Your Ref
M/33/15/HH
Our Ref
PLAN-009400
Date
15/04/2015

Proposal: Loft extension

Site: 46 Lane End Road, Ancton, Middleton-on-Sea, PO22 6LT.

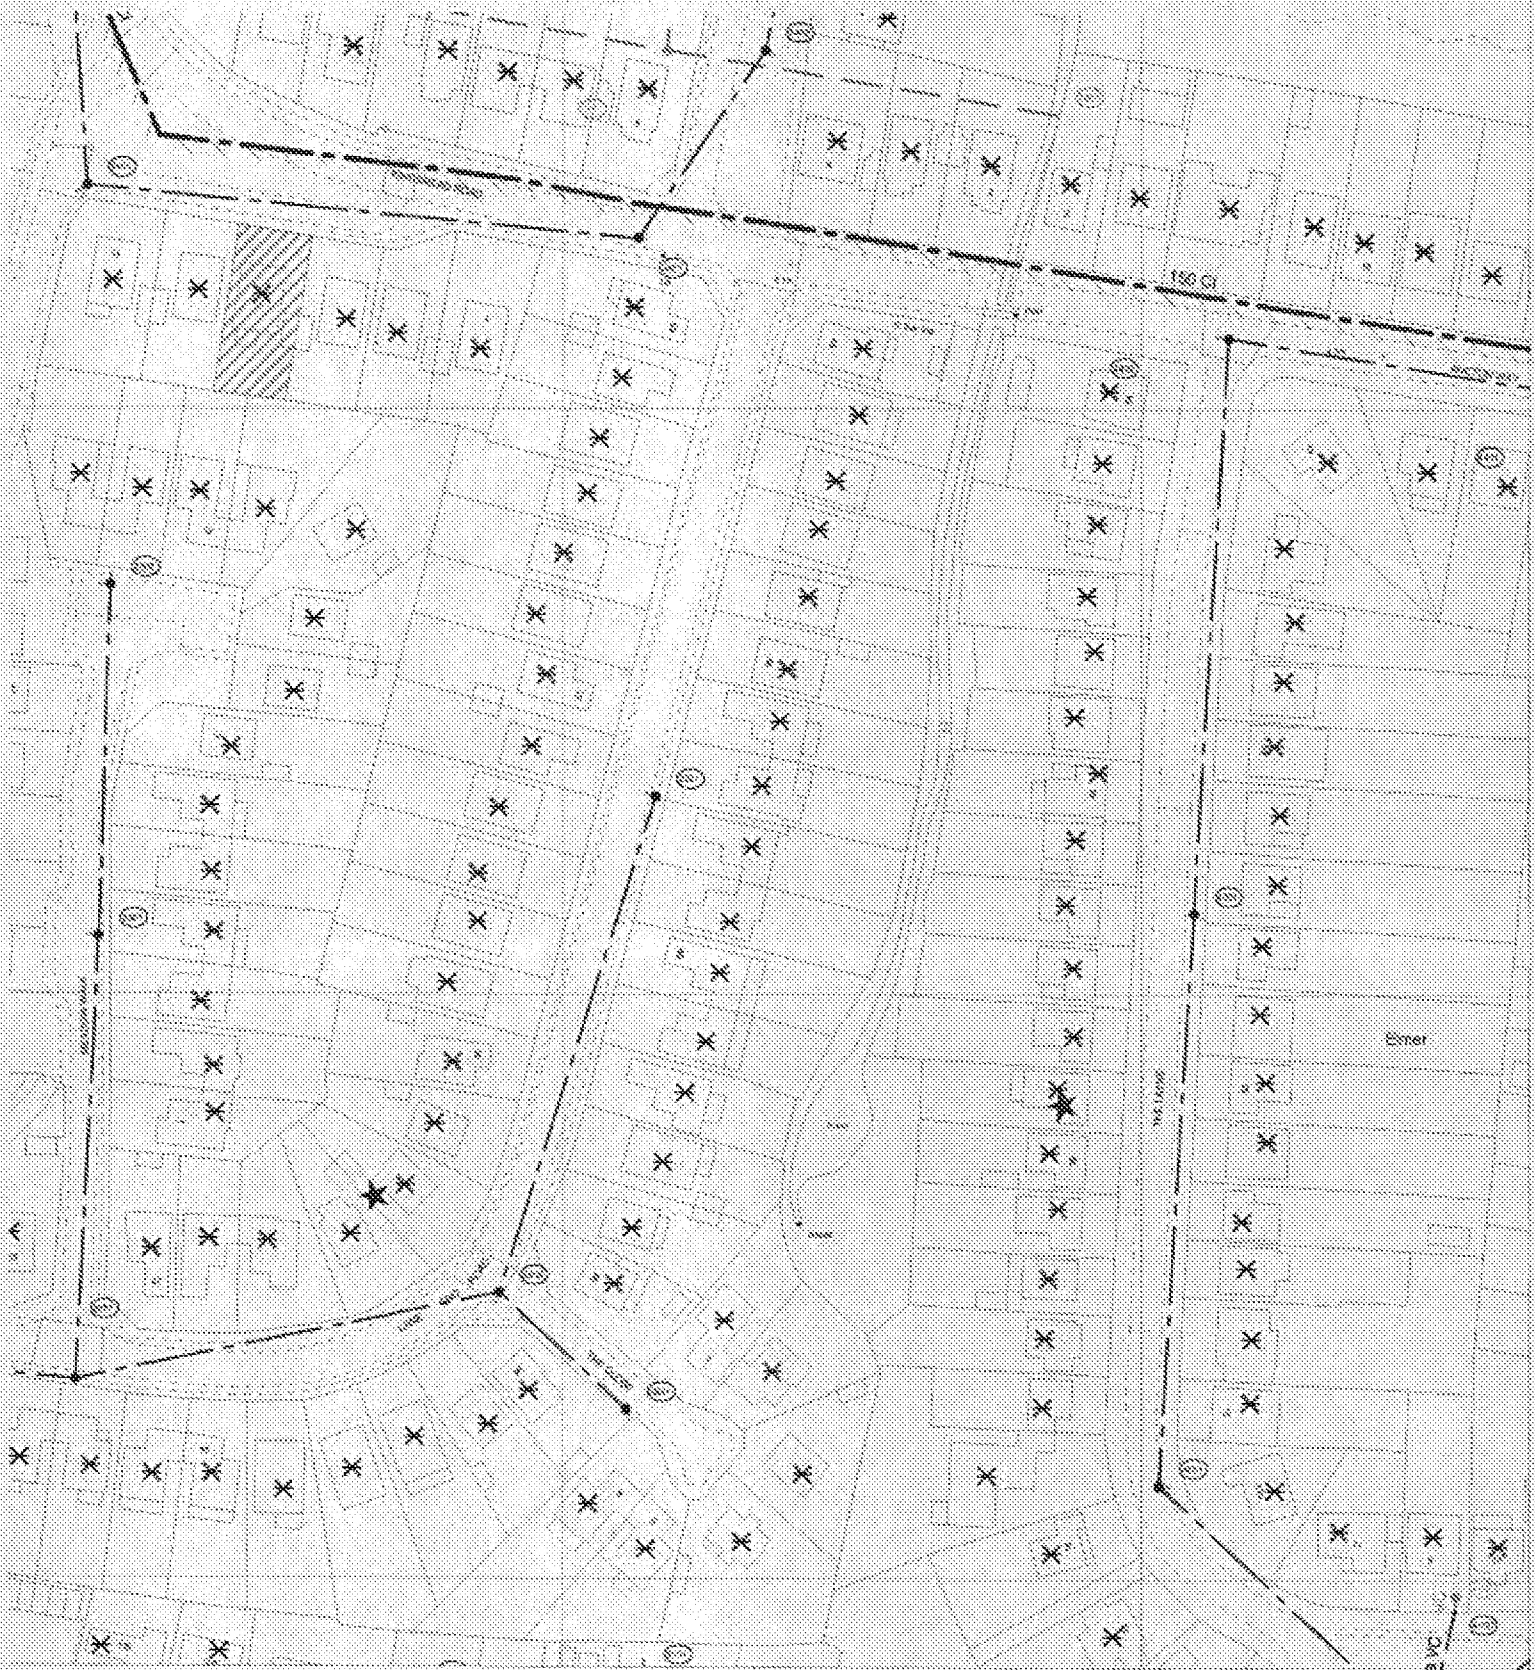
Due to changes in legislation that came in to force on 1st October 2011 regarding the future ownership of sewers it is possible that a sewer now deemed to be public could be crossing the above property. Therefore, should any sewer be found during construction works, an investigation of the sewer will be required to ascertain its condition, the number of properties served, and potential means of access before any further works commence on site.

The positions of pipes shown on this plan are believed to be correct, but Southern Water Services Ltd accept no responsibility in the event of inaccuracy. The actual positions should be determined on site.

WARNING: BAC pipes are constructed of Banded Asbestos Cement

WARNING: Unknown (LINE) materials may include Banded Asbestos Cement

The applicant is advised to discuss the matter further with Southern Water, Sparrowgrove House, Sparrowgrove, Otterbourne, Hampshire SO21 2SW (Tel: 0330 303 0119) or www.southernwater.co.uk".
